ADDENDUM NO. TWO

JOB NAME: NOBLESVILLE CITY HALL CONTROLS UPGRADE

PROJECT NUMBER: 24-800-036-1

DATE OF ADDENDUM: 06/21/2024

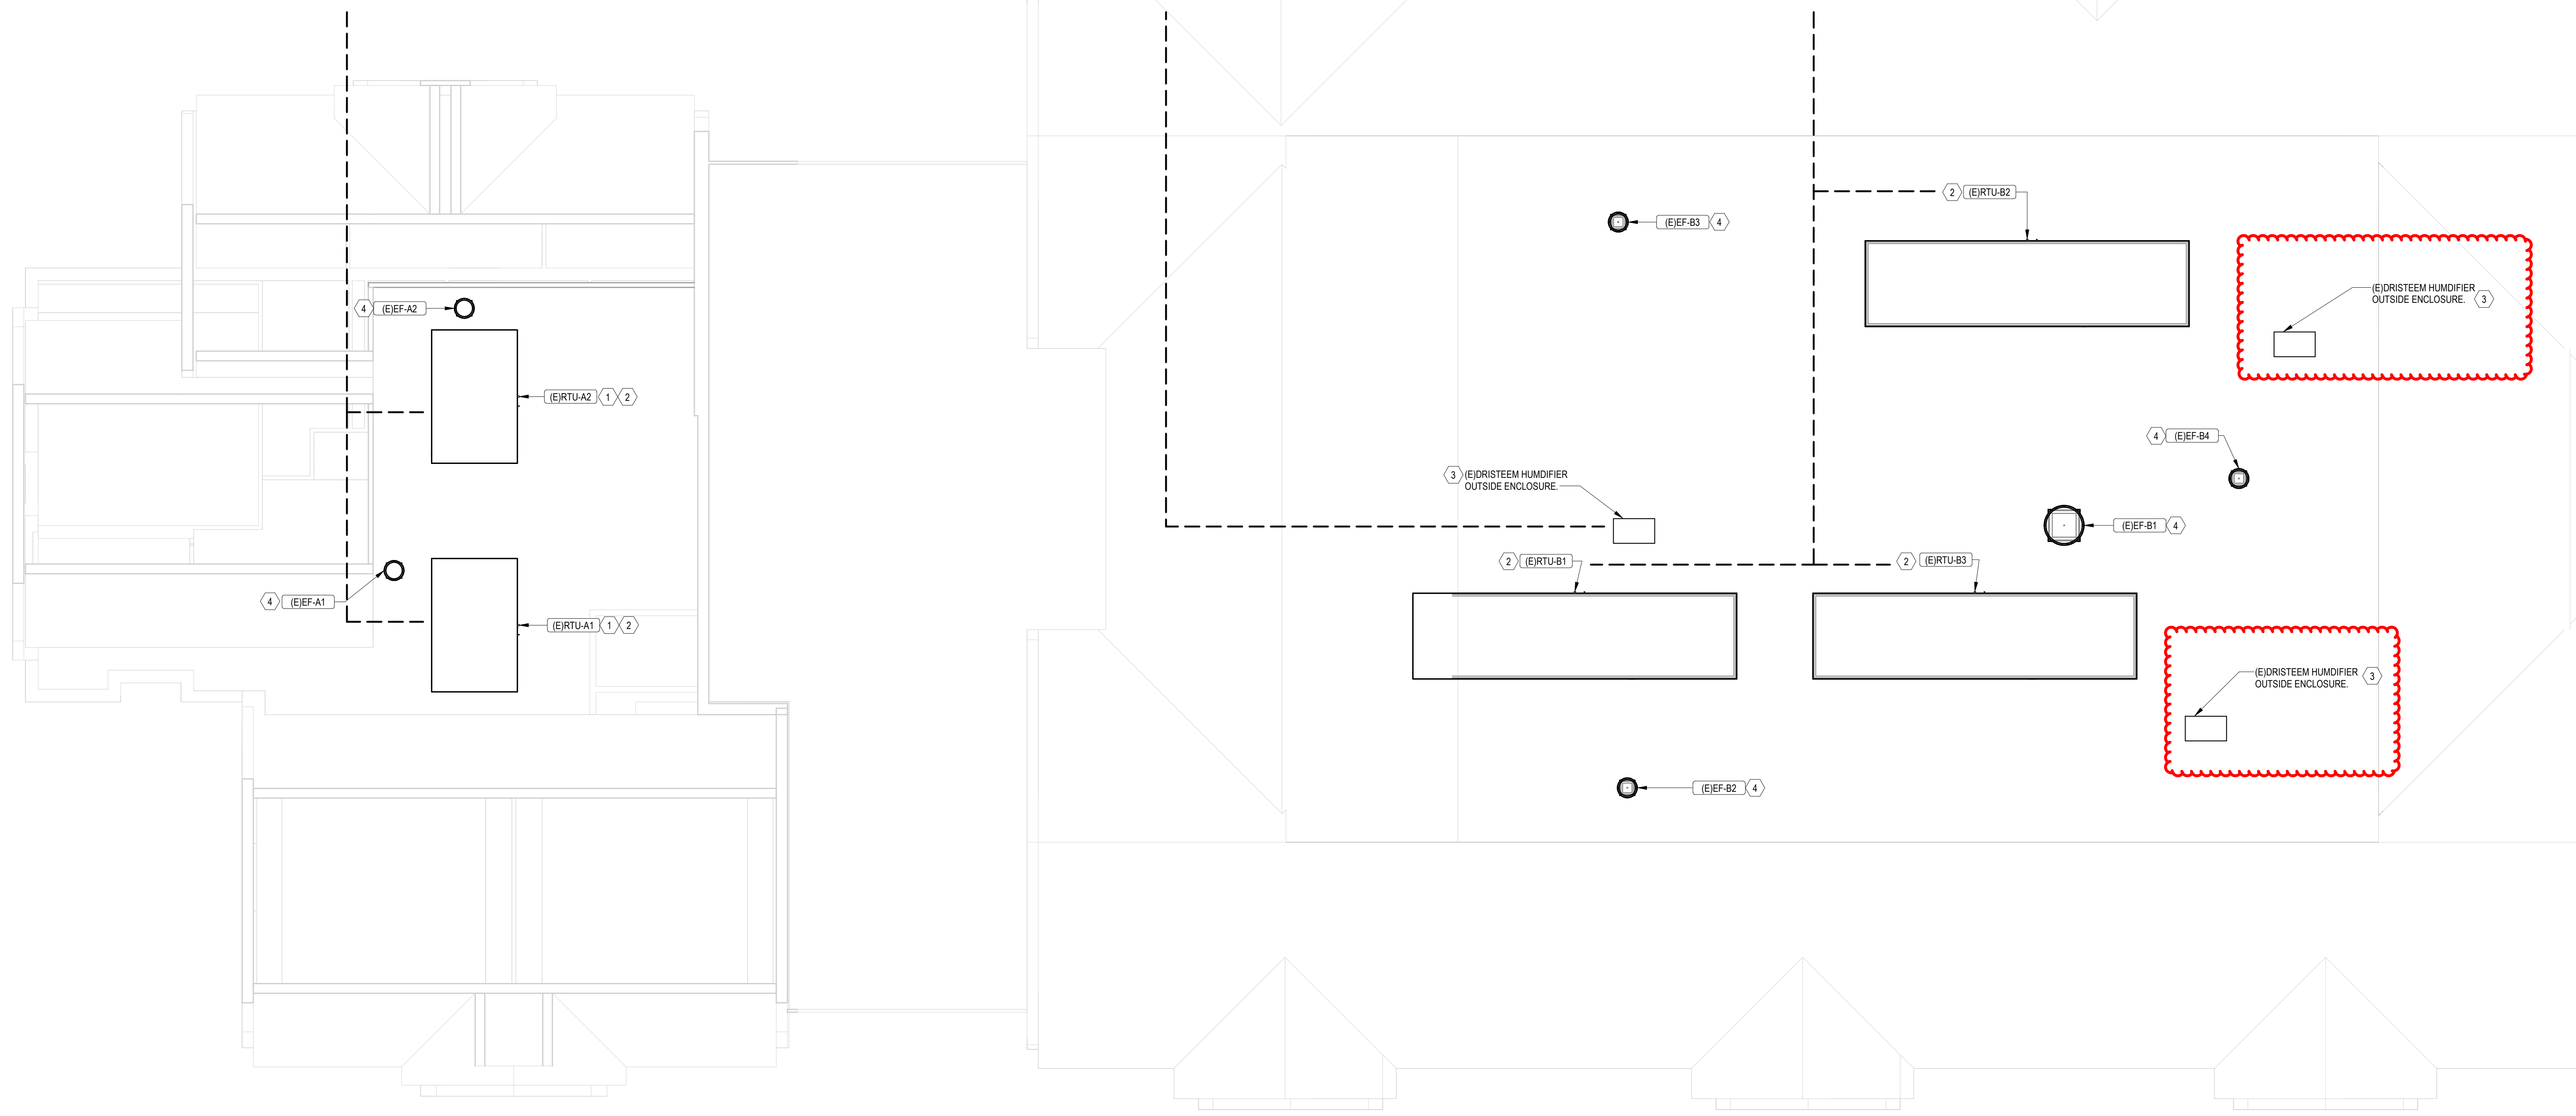
4. The new VFD's in Alternate #2 shall have a bypass.
5. There are three (3) Humidifiers that share a control cabinet on the roof. The Schedule index of equipment on sheet M600 has always shown these but revisions have been made to Sheet M230 showing equipment tags to ensure clarity and consistency.

1. M-230 – Roof Mechanical Plan
 - a. Added Tags for Humidifiers on the roof to match the tags for the humidifiers in the equipment index on sheet M600
